**OHIO TURNPIKE AND
INFRASTRUCTURE COMMISSION**

ADDENDUM NO. 1

PROJECT NO. 39-18-02

**PART A - MAINLINE PAVEMENT RECONSTRUCTION, MILEPOST 169.74 TO MILEPOST
176.34, SUMMIT AND CUYAHOGA COUNTIES, OHIO**

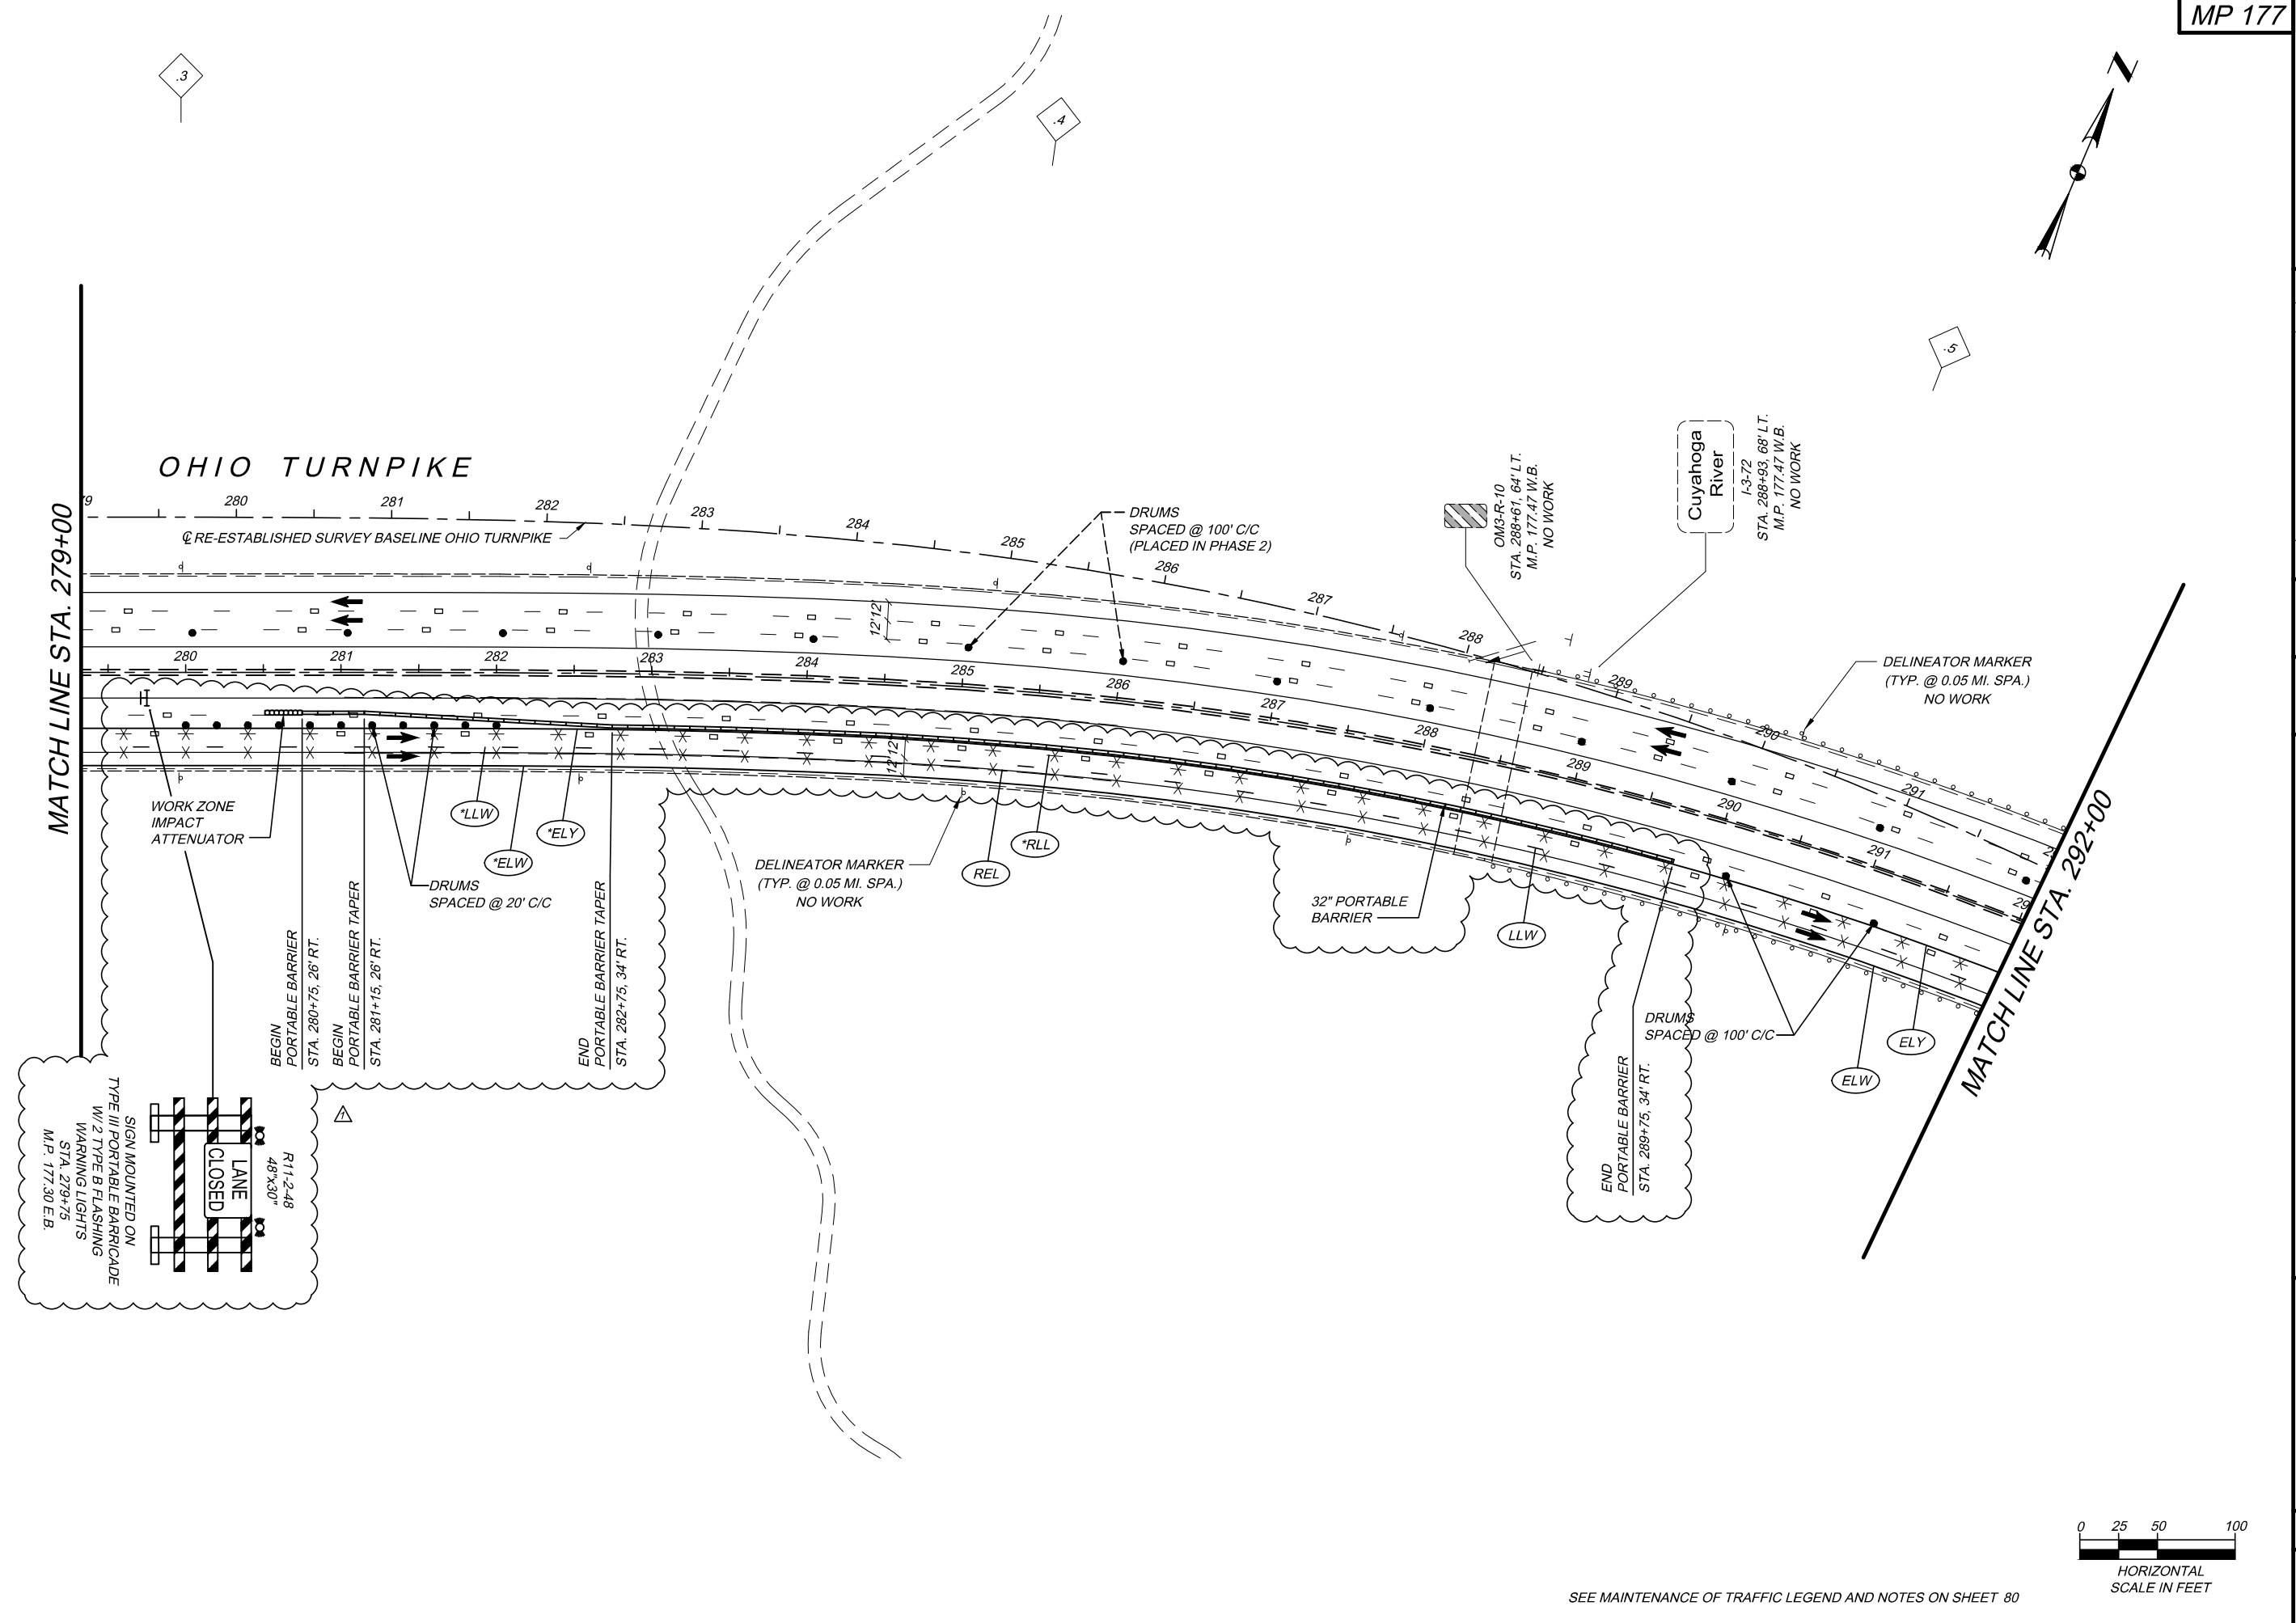
Q#19 MOT general note plan sheet 39 under phase 2, second to last paragraph: this phase allows the contractor to replace the eastbound approach slab at the west end of the Cuyahoga River bridge (MP 175.95, station 255+65) in 2 phases totaling 60 days. The zone is detailed on plan sheets 197 and 206 showing portable barrier protecting this work area. There is also another approach slab which is to be replaced on the east end of the bridge around station 288+50. There are no MOT notes specific to when this is to be replaced and the same phase 2 MOT scheme doesn't show portable barrier protecting this approach slab. Please review the MOT notes and plans and specify zone work, timeframes, and details for this east-end approach slab replacement at the eastbound side of the Cuyahoga River bridge.

A#19 This Addendum No. 1 revises Plan Sheets 39, 56, 64, 199 and 208 of 727 to detail the work zone to replace the approach slab at MP 177.47 (STA 288+33) and the adjusts the quantity accordingly for Ref. No. 197 of the Bid Form and Estimated Quantities Worksheet.

PROFILE SHEET
STA. 955+00 TO STA. 969+00

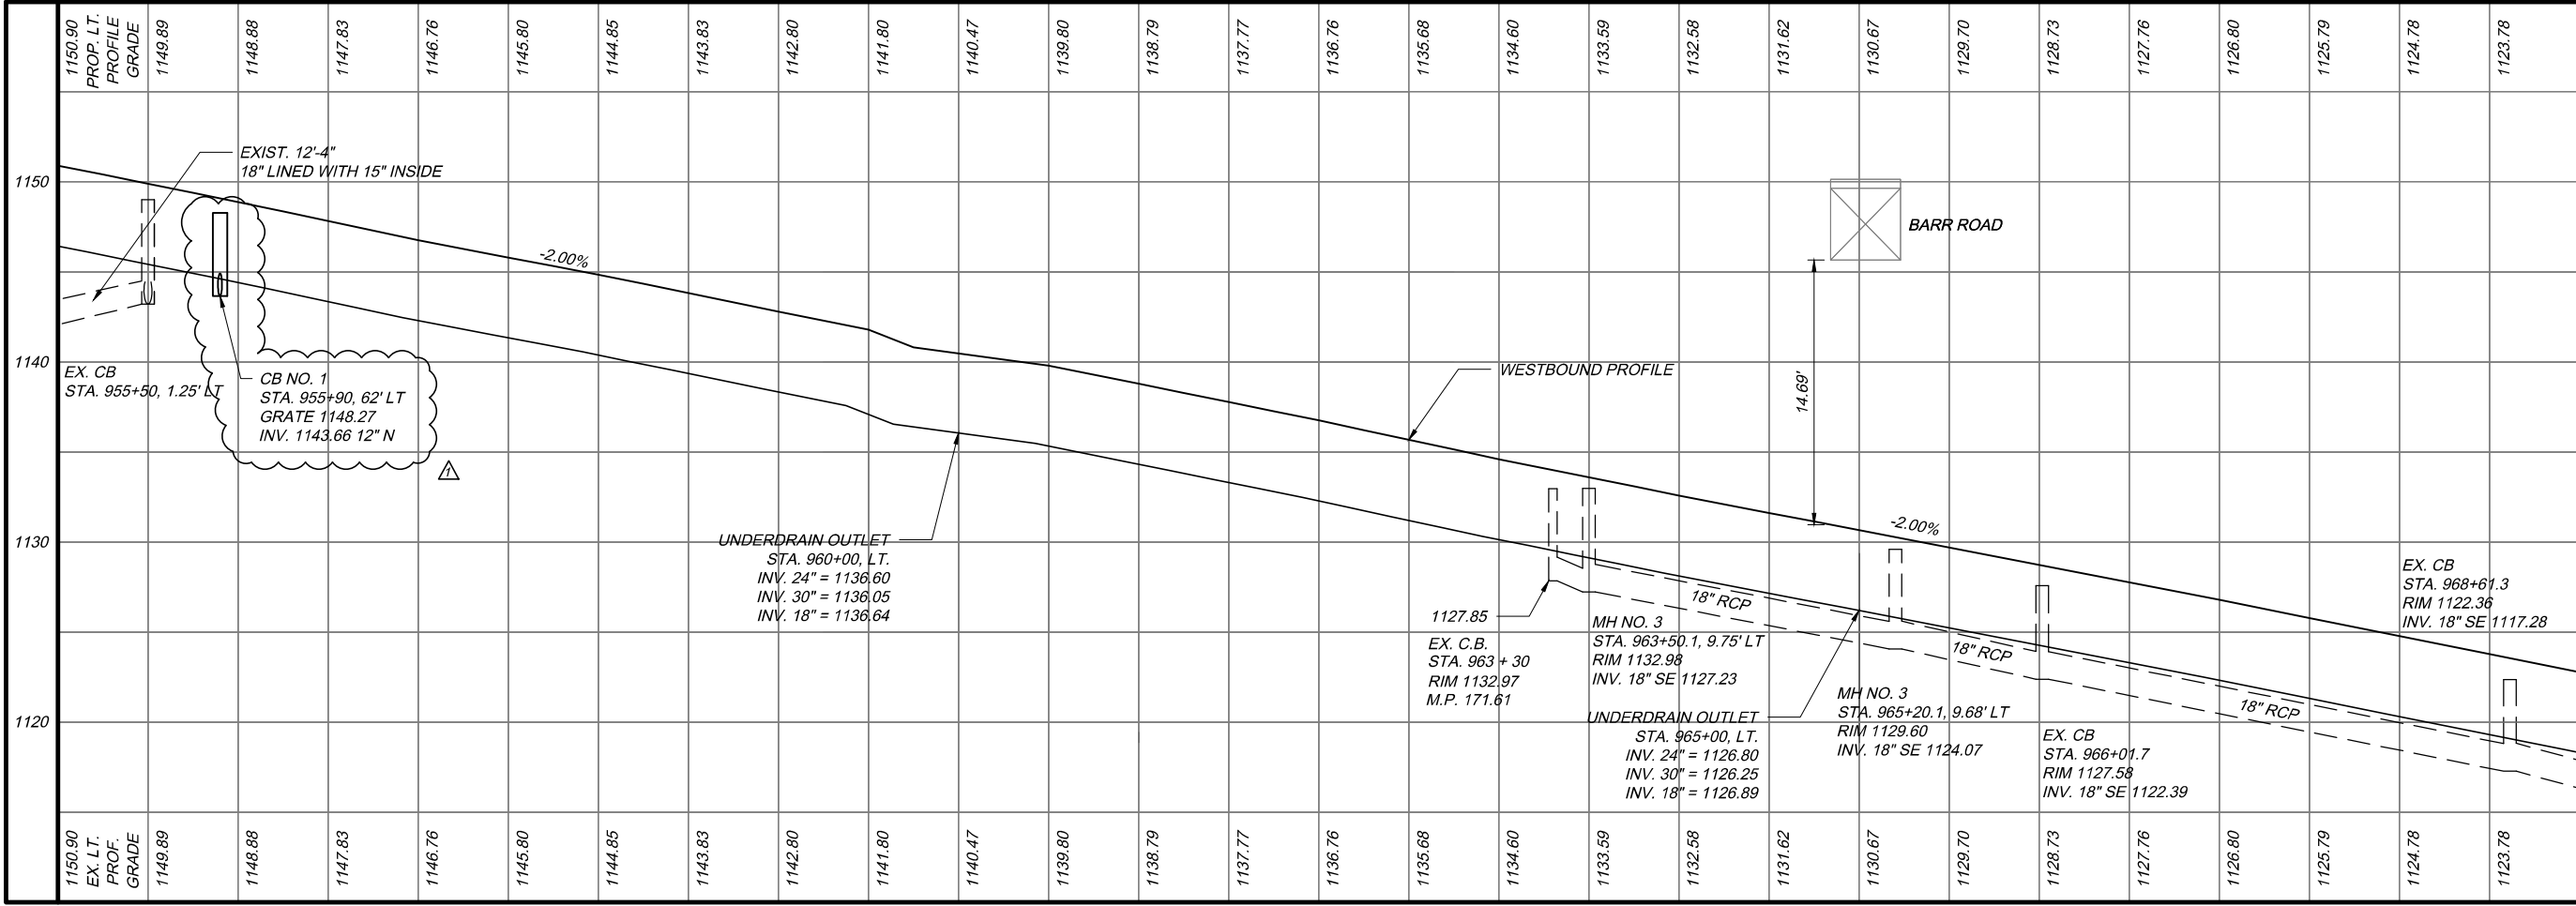
Q#8 Bid item 1340 Catch Basin #CB-1: 2 of the 5 basins do not have top of grate and invert information provided as was provided with the other 3 basins in the profile drawings. Please provide this information.

A#8 *This Addendum No. 1 revises the catch basin information by adding the top of grate and invert elevation to Plan Sheets 428 and 434 of 727.*

PLAN, WESTBOUND

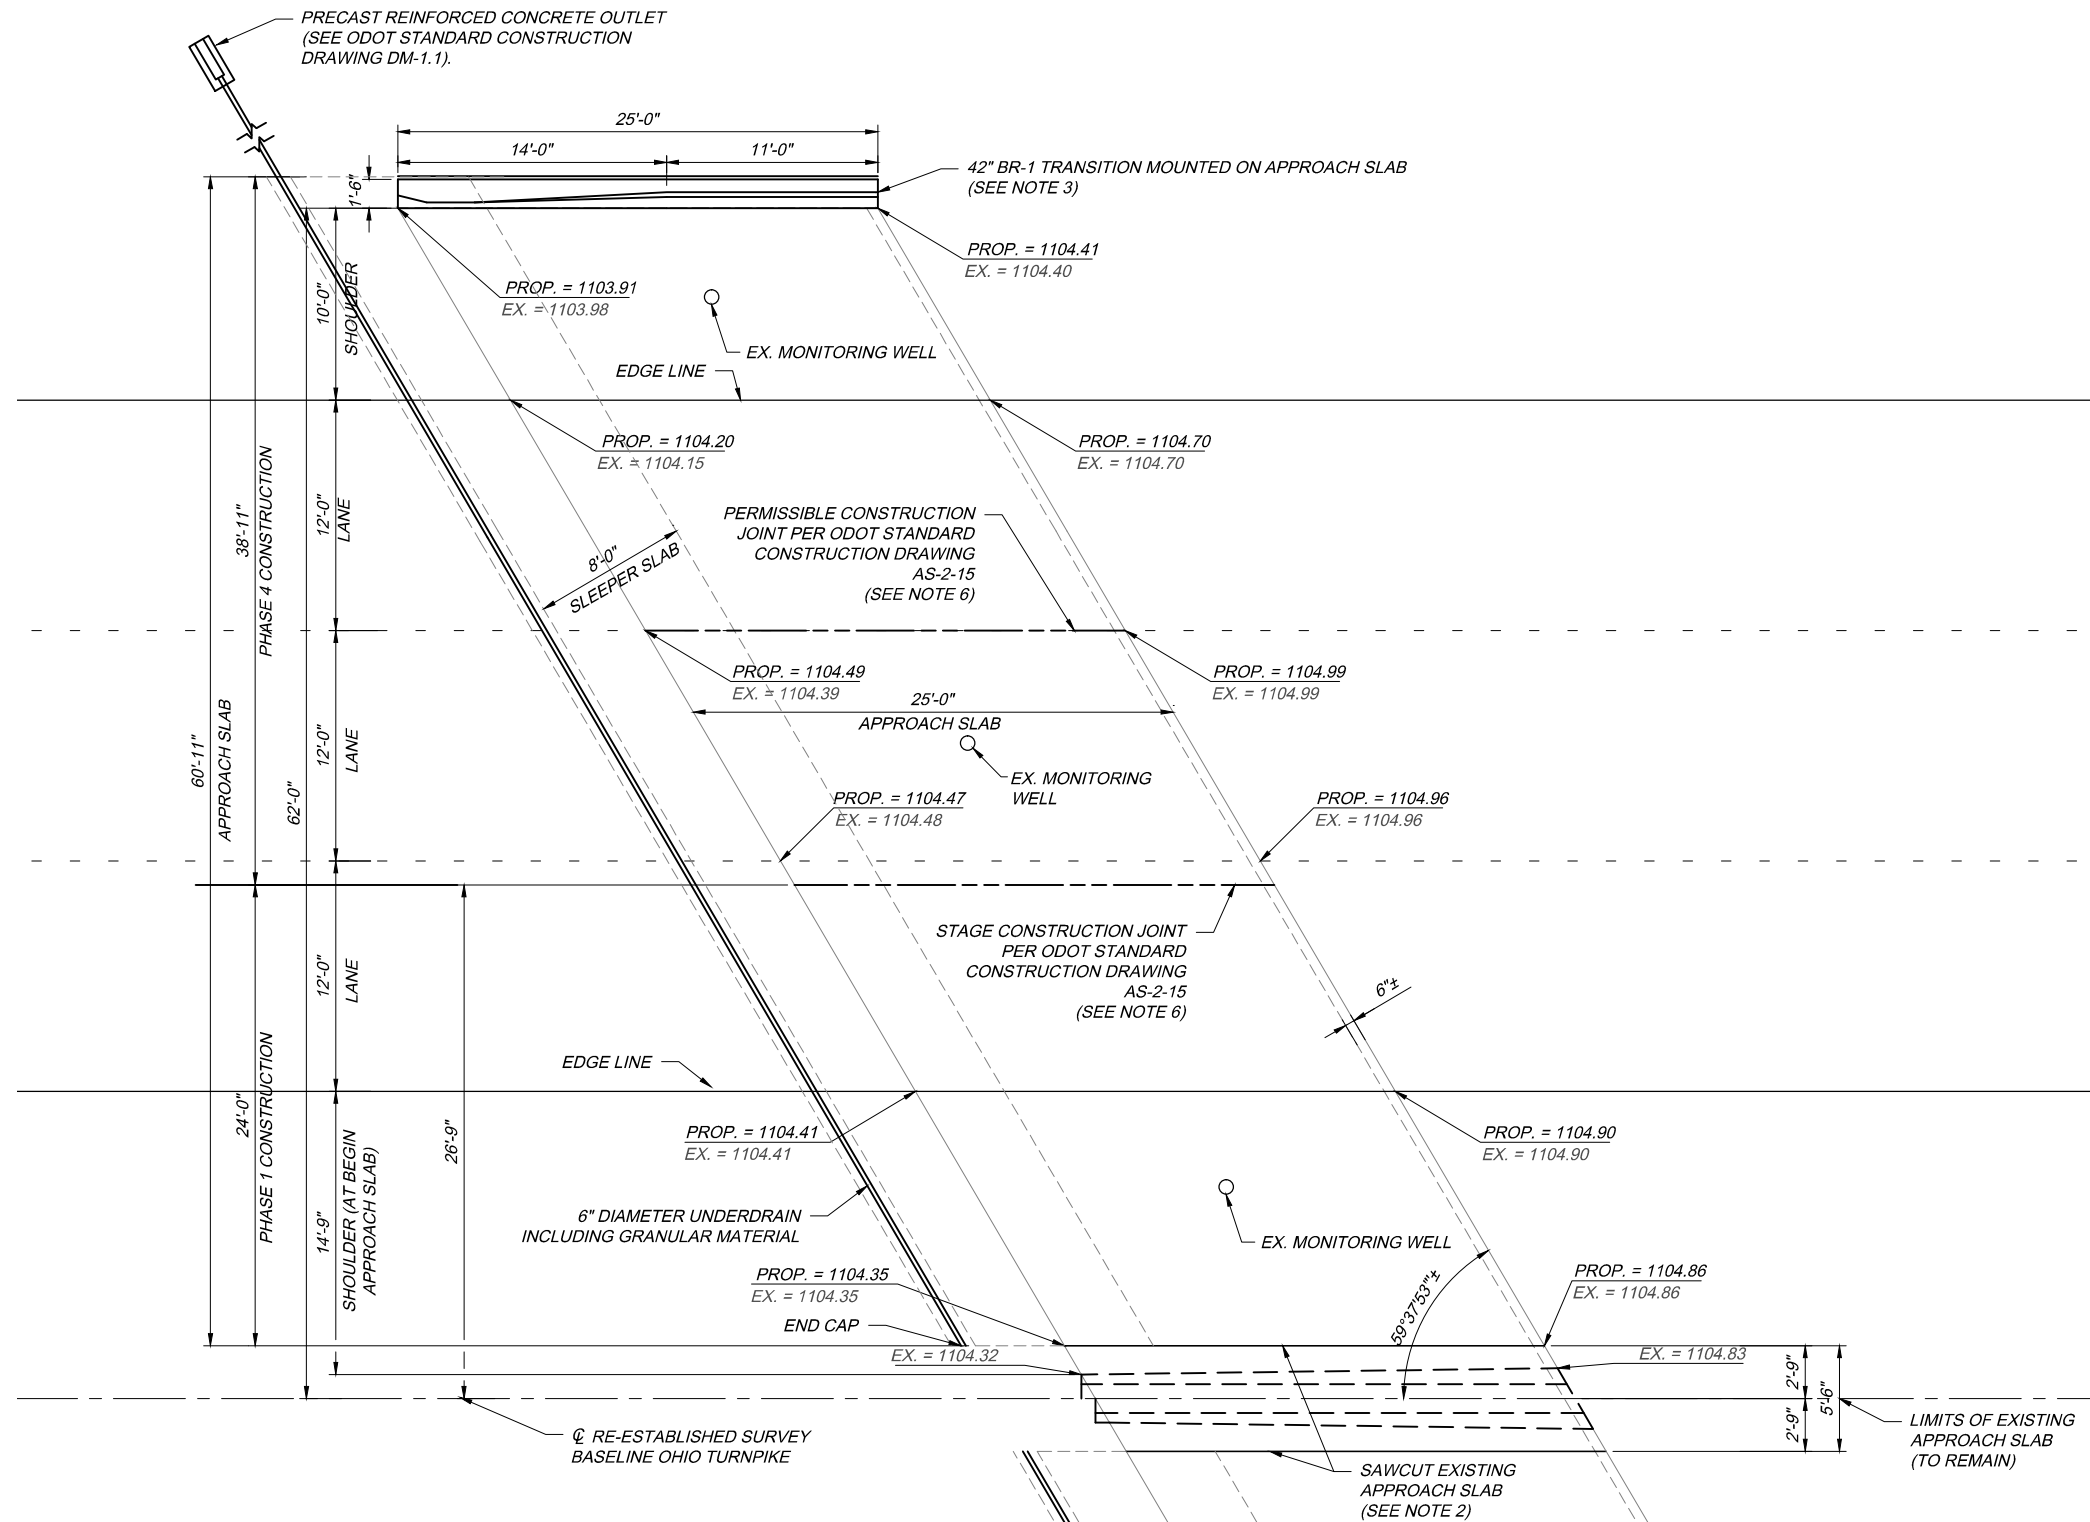
Q#18 Please review the approach slab removed items 13-16 (approach slabs removed types 1 -4) as per plan notes on plan sheet 33 and the notes specifying the type of removal on plan sheets 688-698. None of the removal pay items specified on sheets 688-698 seem to match

the notes on sheet 33 for the work that is required to be completed. Plan sheets 696 & 697 do not specify which item to pay the removal under. Please review the quantities for pay items 13-16 as well and revise as needed.

A#18 This Addendum No. 1 revises the removal pay items specified on Plan Sheet 688 to 698 of 727 to match the notes on Plan Sheet 33 of 727. The quantities for Ref. No. 13 through 16 are correct.

4. REMOVAL OF THE EXISTING APPROACH SLAB IS INCLUDED UNDER ITEM 202 - APPROACH SLAB REMOVED, TYPE 2, AS PER PLAN. NEW APPROACH SLAB IS INCLUDED UNDER ITEM 526 - REINFORCED CONCRETE APPROACH SLAB, (T=15\"), AS PER PLAN.
